HYDROLOGY

M16/D25

STANDARD REQUIREMENTS FOR DRAINAGE PLANS

1 PLAN

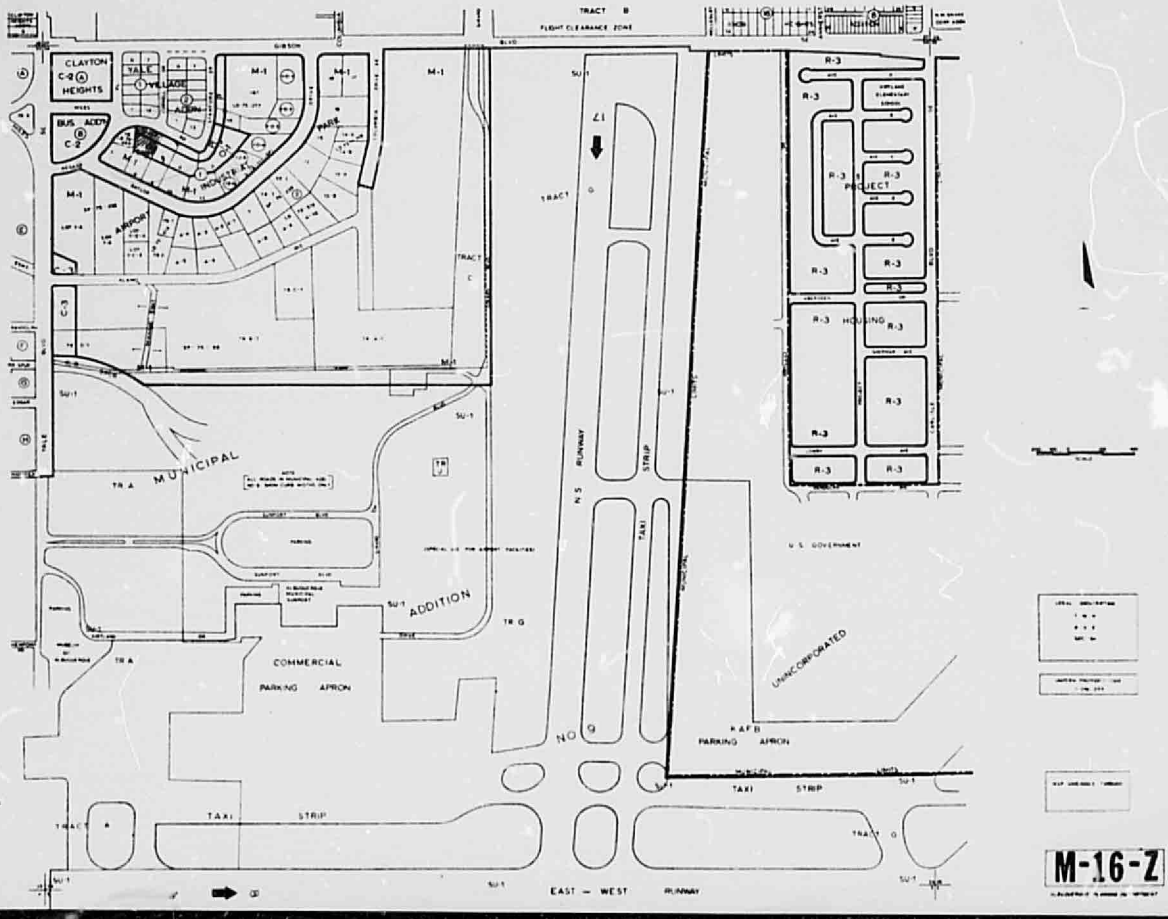
1) WHAT AREA IS DRAINING TO THE POND?

2) WHAT OFF-SITE FLOWS ARE INTERCEPTED BY YOUR LOT AND HOW DO YOU PLAN TO HANDLE IT?

3) SITE PLAN MUST OUTLINE EACH DRAINAGE AREA.

4) POND CONFIGURATION DOES NOT AGREE WITH THE SPOT ELEVATIONS, IE A 3:1 SLOPE IS TO BE MAINTAINED.

5) ORTHO-TOPO MAP DISAGREES WITH YOUR SURVEY.
